**Model:** DVP-S360, DVP-S560D, DVP-S570D**No.** 77**Subject:** SYSCON ROM Update**Date:** December 19, 2001**Symptom:  
(1185)**

**MB-86 Board (Side B)**

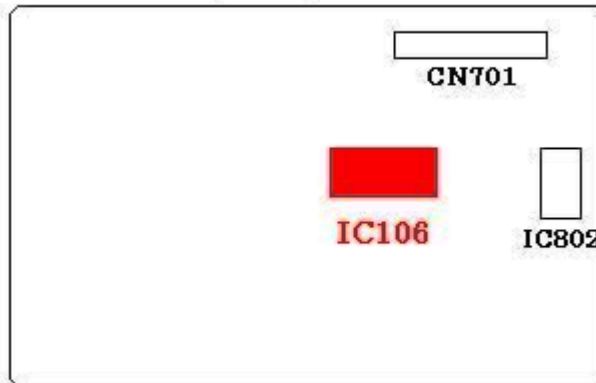
2. Replace IC 106 with the SYSCON ROM from the table below.

MODEL TYPE	Ref. No.	PART NUMBER	DESCRIPTION
TYPE 1	IC106	8-759-828-72	IC MR27V1602E-39TPZ060
TYPE 7	IC106	6-800-101-01	IC MR27V3202E-A4TPZ060
TYPE 8	IC106	6-800-102-01	IC MR27V3202F-A5TPZ060
